INTERNAL MEMORANDUM
Highways, Transport & Environment

Proposal: Hybrid planning application comprising 1) full planning application for A1 retail food store with car parking and associated ancillary development and 2) outline permission for circa 80 dwellings and associated access with all other matters reserved.	Date:	13/02/17		
Location: Former Site Of Blakeston School, Junction Road, Norton	Ref:	16/2445/FUL	Rev	2

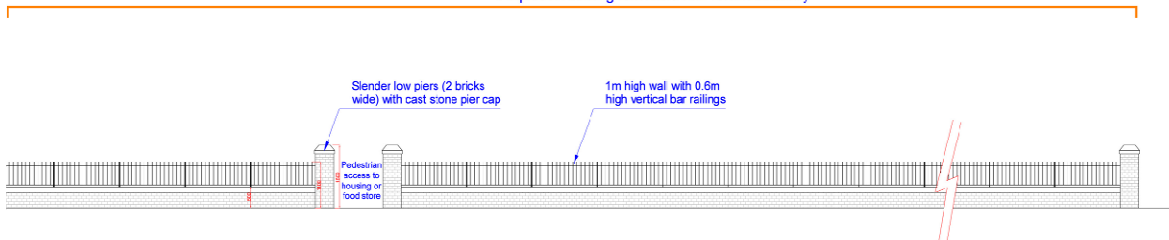
The soft landscape proposals for the site in terms of species and stock sizes are generally acceptable.

A landscape maintenance plan will be required to ensure maintenance of this area is carried out on a regular basis to minimise overhanging. It should ensure the planting establishes and all losses/gaps are made good. This plan must detail how branches that overhang the highway are to be dealt with so as to avoid damage to the highway or a safety concern arising, but this may be conditioned.

Proposed Housing Site and Food Store Boundary

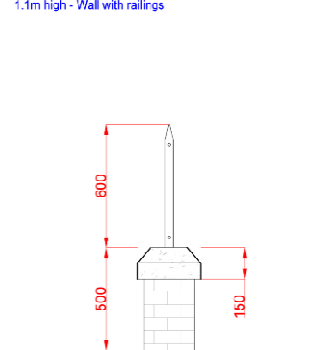
The proposed boundary treatments require some further consideration. The proposed timber acoustic barrier fencing surrounding the plant area is acceptable, and should be partially screened by the proposed soft landscaping facing Blakeston Lane. However, the proposed mesh fencing to the northern and eastern boundary must be reconsidered in line with previous comments. This fencing demarcates the boundary between the store and the proposed residential development. As such, it is not a suitable boundary to a residential dwelling, due to its industrial character and open texture which would give no privacy to residents, particularly to the west of the car park. No boundary fencing is proposed to the front of the store along Junction Road. This is unacceptable both visually and for highway safety reasons as previously noted. It is considered that a unified boundary treatment should be adopted across the whole site of the former Blakeston Lane School site (which would take its lead from the extant crematorium permission) to improve the Junction Road frontage. A wall with railings would also reduce maintenance implications for the adopted highway (footway) where plant growth may encroach on to the highway.

The following sketch proposals indicate a suitable scheme for the area, which the applicant may wish to consider.

Proposed Housing and Food Store Boundary
1.1m high - Wall with railings, or railings

Proposed Housing and Food Store Boundary
1.1m high - Wall with railings

Example Wall - grey coloured materials with simple block coping
